BAR Meeting
November 13, 2013

ISSUE: Permit to Demolish/Capsulate and Certificate of Appropriateness for an Addition and Alterations and a Waiver of the rooftop HVAC Screening Requirement, Section 6-403(B)(3)

LOCATION: 703 South Fairfax Street

BAR2013-00366 & BAR2013-00367

Figure 1. Illustrations showing walls proposed to be demolished / capsulated

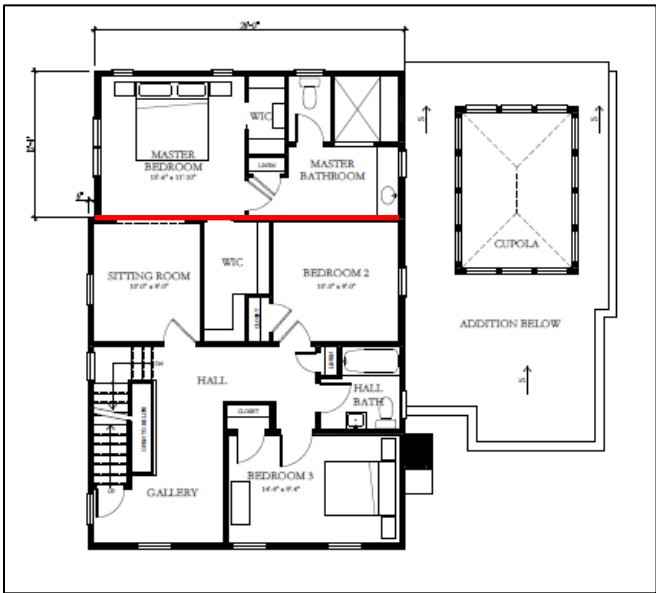
The rear enclosed porch to be demolished was constructed c1958, and is not original to the building. As such, staff does not object to its removal. The demolition of the remaining rear exterior wall surface is minimal (250 sq. ft.), as the majority of the rear wall area on the main house proposed to be demolished is capsulated inside the existing one-story enclosed porch, which was previously not visible or subject to BAR's review.

In case of the north (side) addition, the majority of the first floor of this elevation will either be capsulated or demolished for the construction of this addition. The Board regularly approves partial demolition and capsulation to allow for additions when the existing walls or are not particularly unusual or of uncommon construction. Staff does not find that this particular

elevation contains elements, forms or features which define this building’s architectural style or form. Nor does staff find that the proposed additions would diminish the historic integrity or confuse a future observer about the scale and form of the original house.

In staff’s opinion, the Criteria listed above are not met and the Permit to Demolish/Capsulate should be granted.
